Submissions for the Water Supply, Wastewater and Stormwater Bylaw review

Submissions for the Water Supply, Wastewater and Stormwater Bylaw review

Figure 2 CCC Stormwater pipes in LPC's landholder with hard stand and log yards above. Image from CCC's GIS (<https://gis.ccc.govt.nz/portal/apps/webappviewer/index.html?id=c4ff85ba75724391ae89bf5f773e00d>) on 14/01/2022.

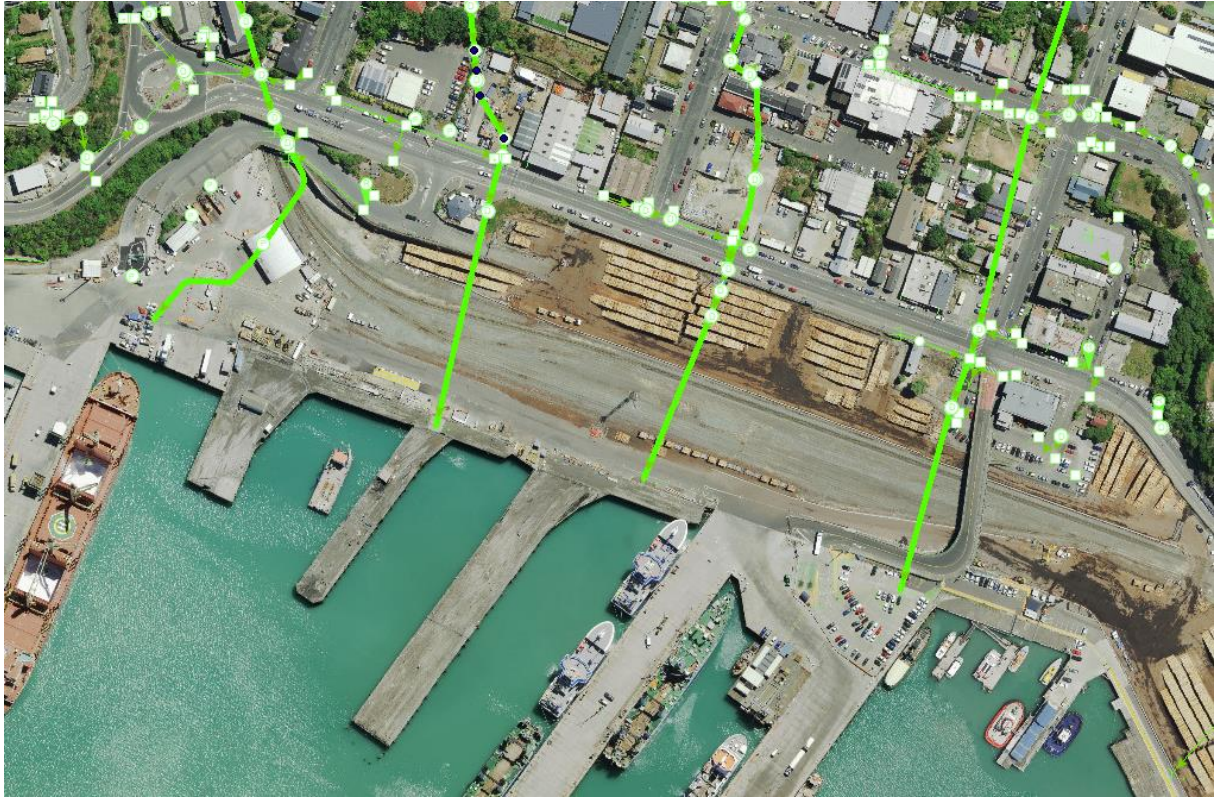
- 20 LPC has a number of CCC owned services through its land holding; particularly at the Port where Lyttleton's brick barrels the land to discharge to the Coastal Marine Area. We are concerned by the proposed Bylaw 17 and implications this may have for LPC's activities. For example the bylaw proposes to include hard stand which is present above the stormwater lines CCC has through the Port (See Figure 2). Having such an assessment on a case-by-case basis is not acceptable to LPC who requires the ability to use land for Port activities to operate safely and efficiently. We ask CCC to consider if the bylaw should contain certain exclusions for operations such as LPC.
